In response to Harry Mitchell's recent landscape comments regarding plot boundaries, for Plots 75 and 100, which back onto the woodland edge, a timber fence is considered appropriate in this context. We consider that timber panels with concrete posts provide a practical solution, offering durability and ease of maintenance and replacement over time.

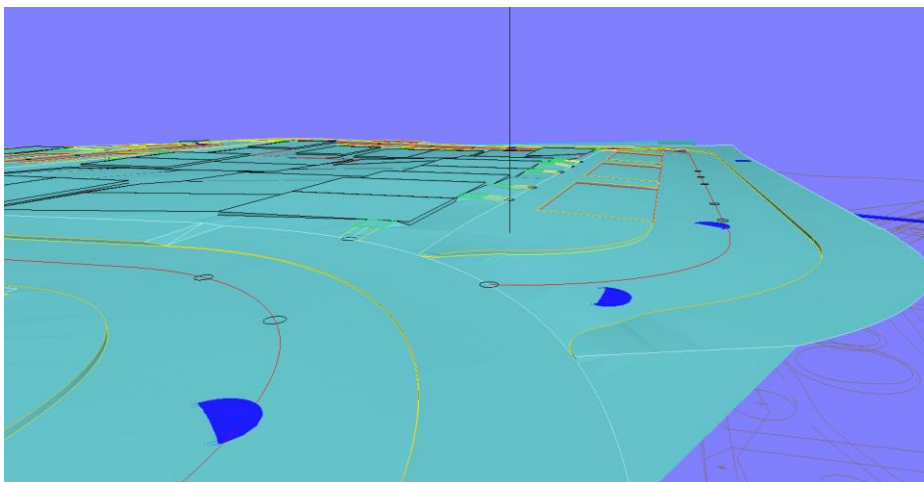
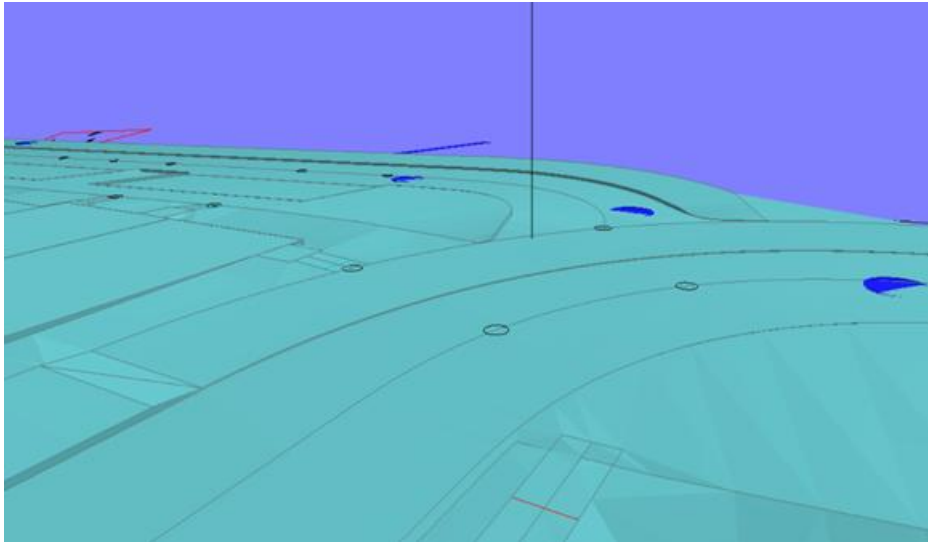
Following Harry Mitchell's comments regarding the levels around the southern cycleway junction, the screenshots below are for visual reference from modelling, and the updated levels layout plan is attached. There is a change in levels, but this would be marginal.
